Rail Coach Factory, Kapurthala

Sub: Retro-fitment of Enhanced Capacity Pantry Equipment in existing LHB AC Hot Buffet Coach.

CAI NO.: ED/CAI/041 dated: 09.04.2025

COACH ALTERATION INSTRUCTION FOR
RETRO-FITMENT OF ENHANCED
CAPACITY PANTRY EQUIPMENT IN
EXISTING LHB AC HOT BUFFET COACH

Annexure-D to ED/CAI/041dated08.04.2025

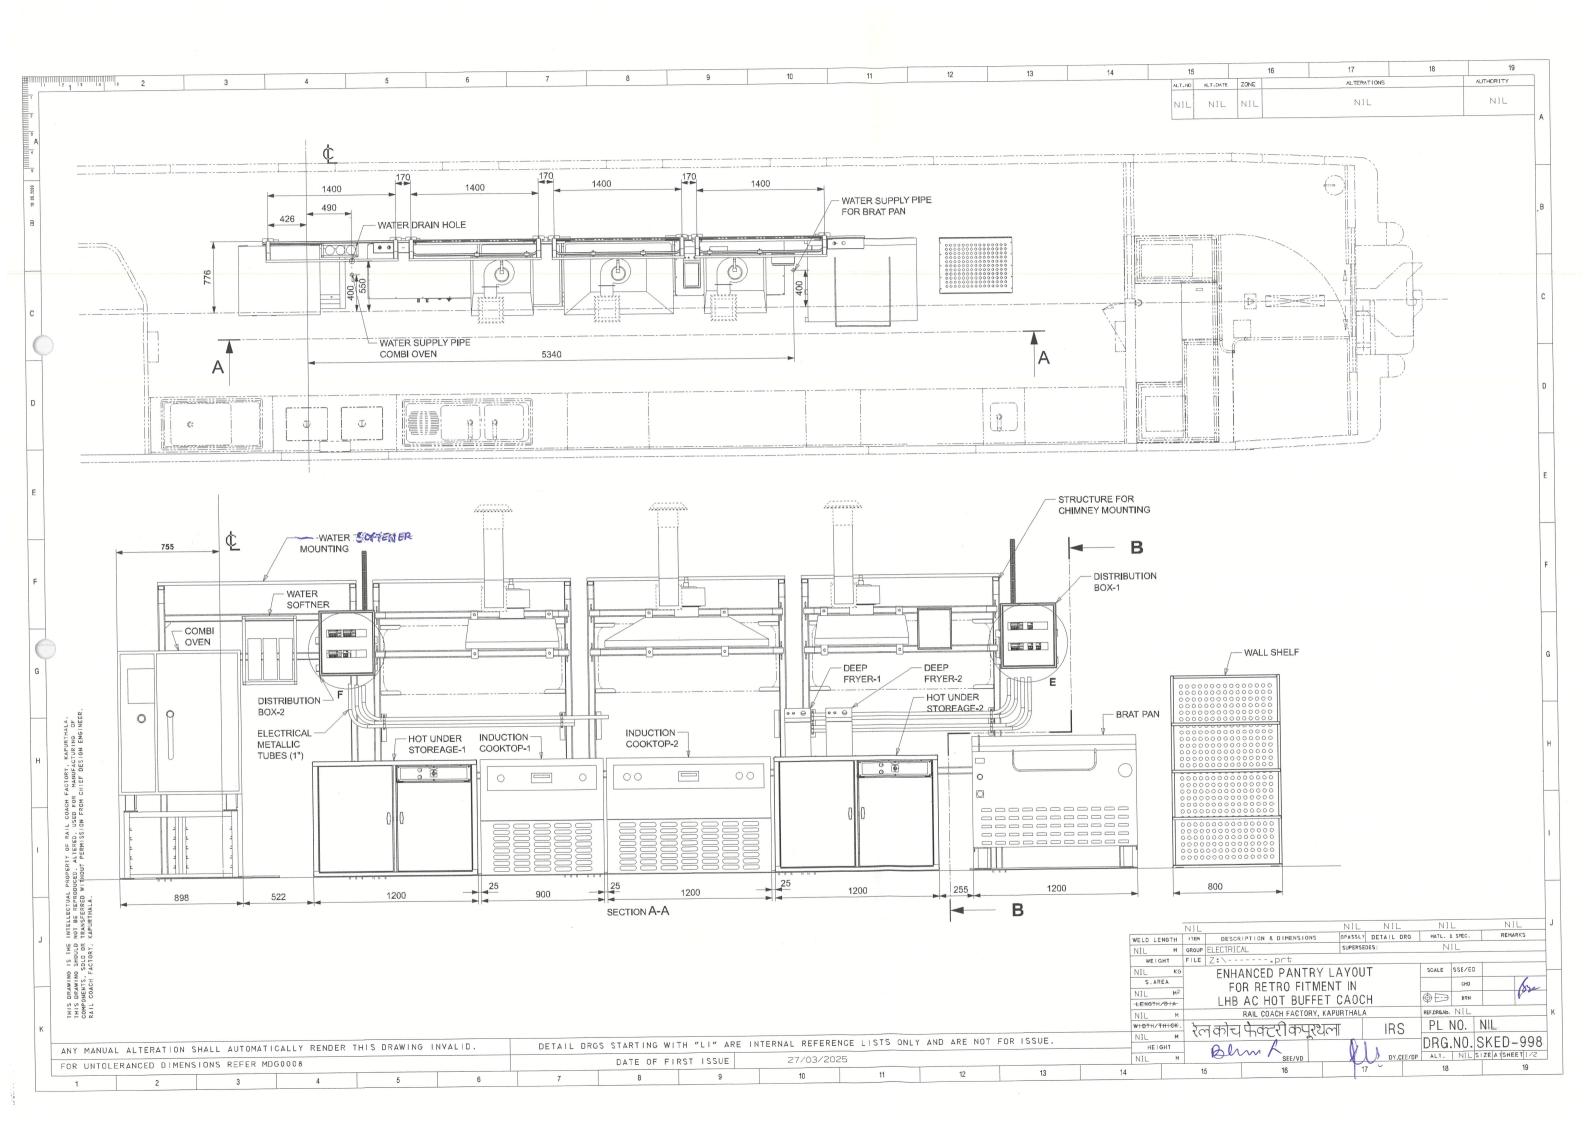
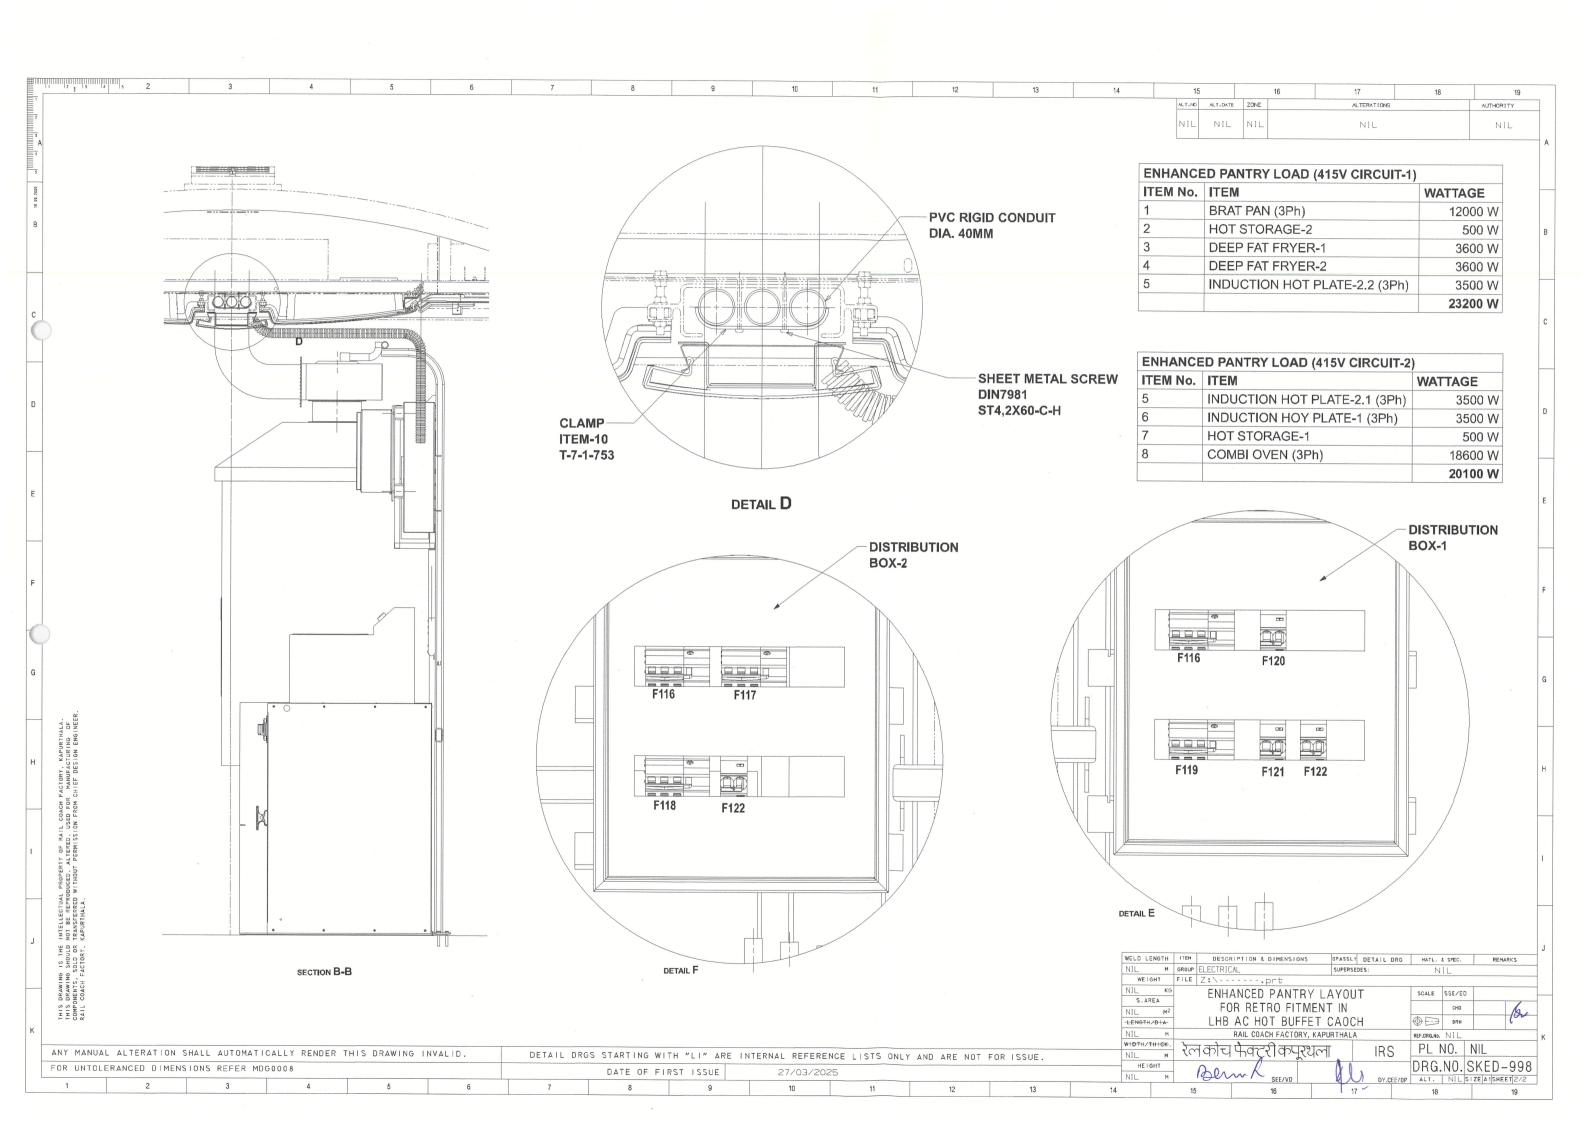
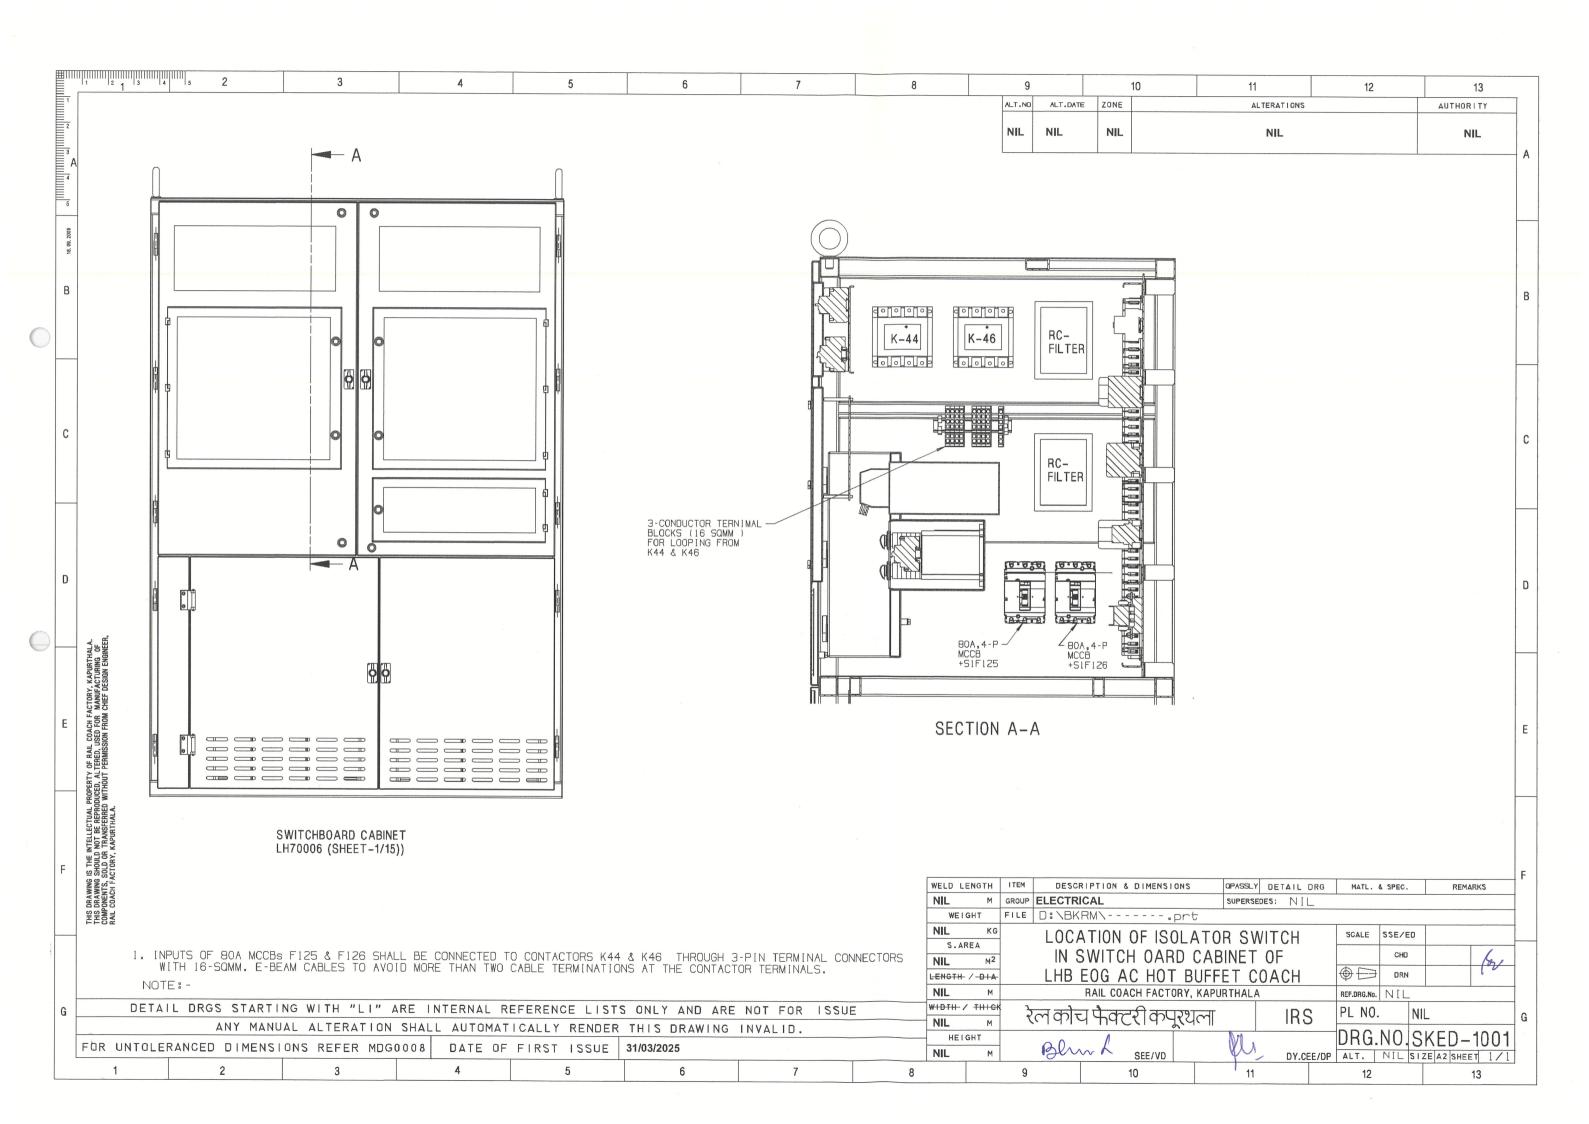
i) The existing equipments on the side wall (as per RCF specification **EDTS 118 (LATEST)** and existing coach layout **LH90001** to be retained as per under given details:

Note: Existing Chimneys alongwith Control box shall also be retained.

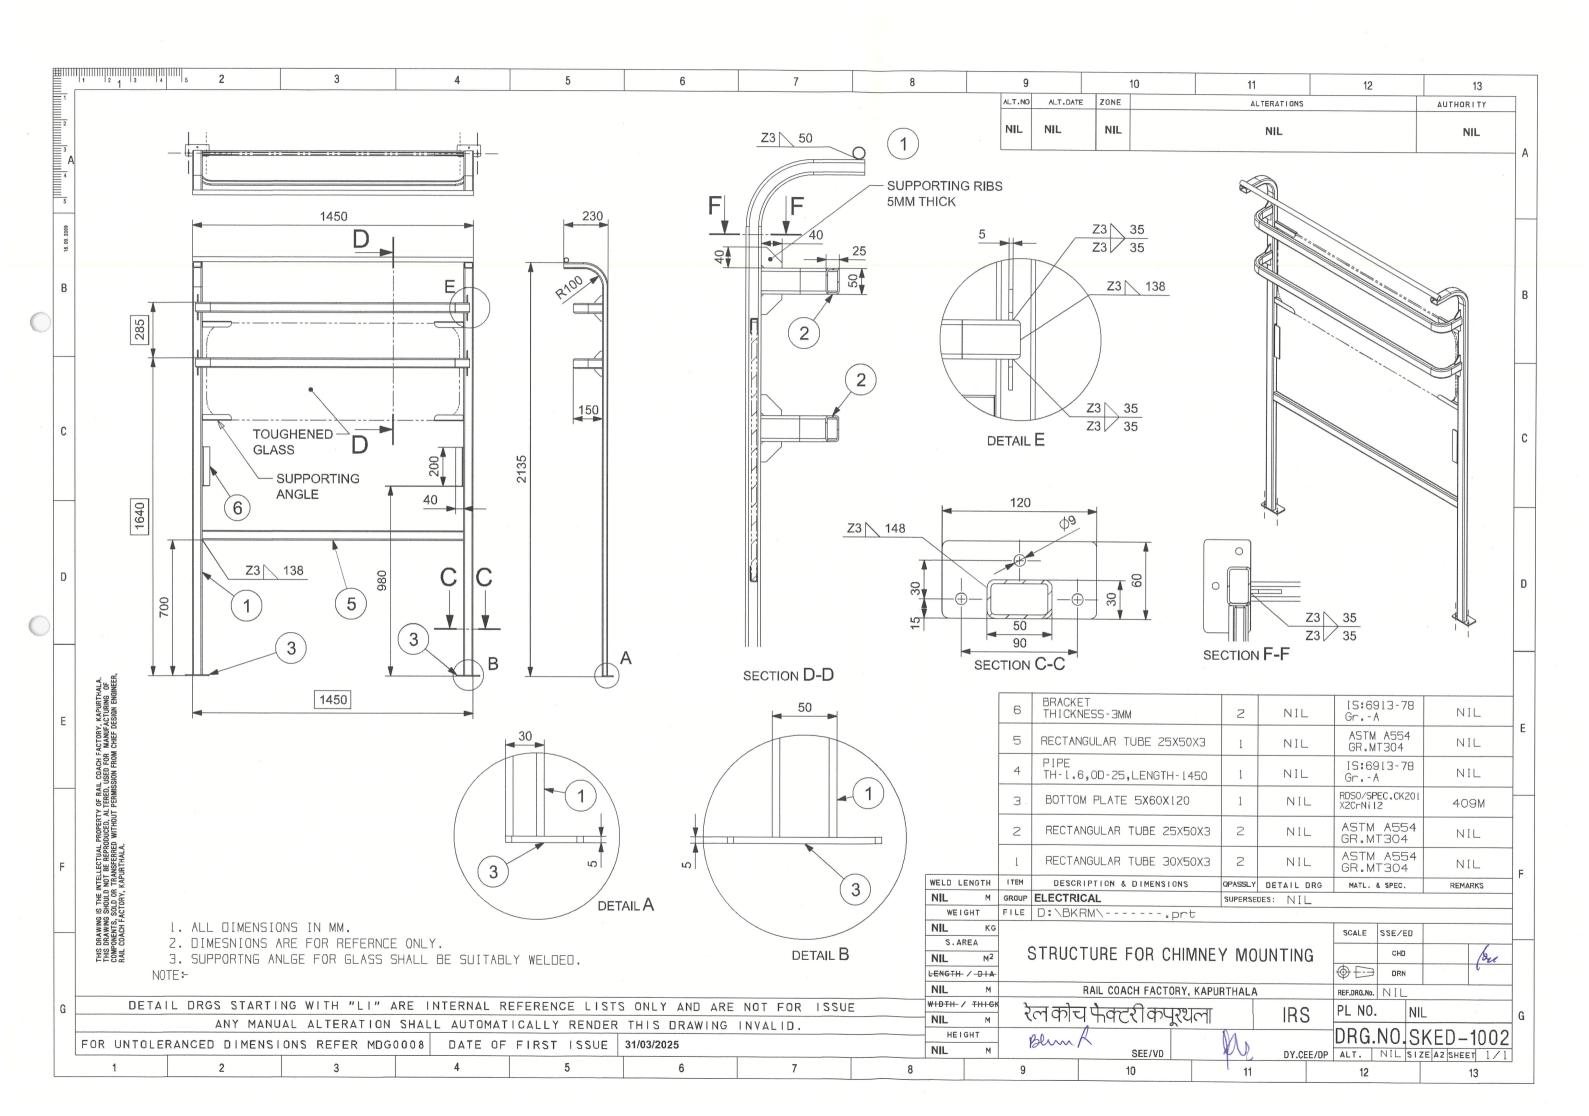
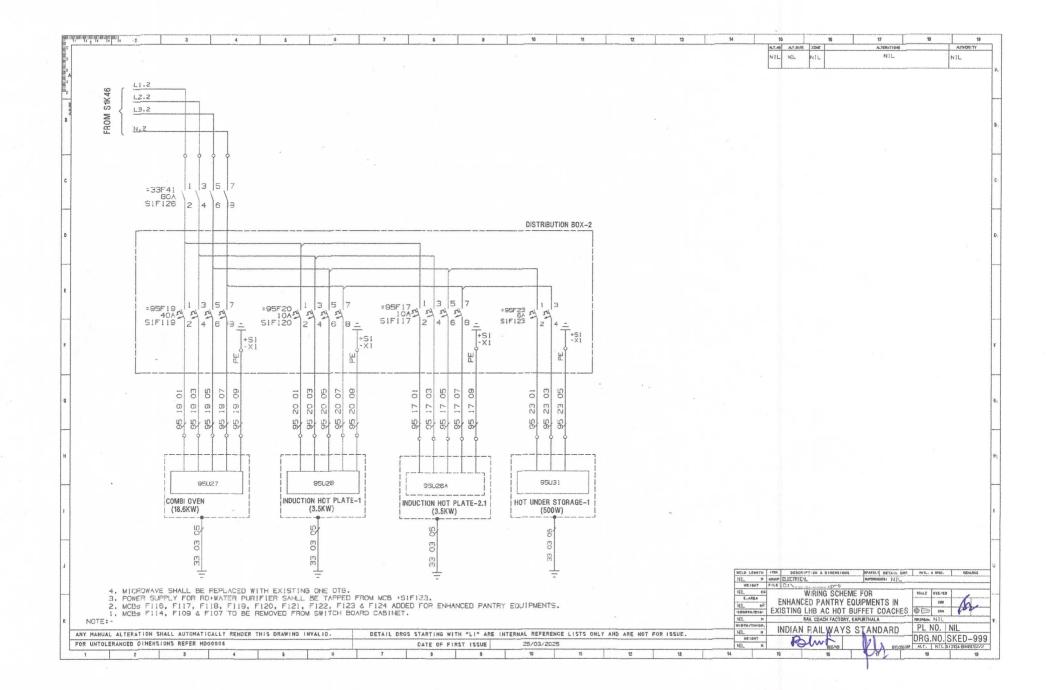
ii) Details of enhance capacity pantry equipments to be provided in central Aile side of the hot buffet coach as per RCF spec. **EDTS 446 Rev. 0, AM-1** shall be as per undergiven details:
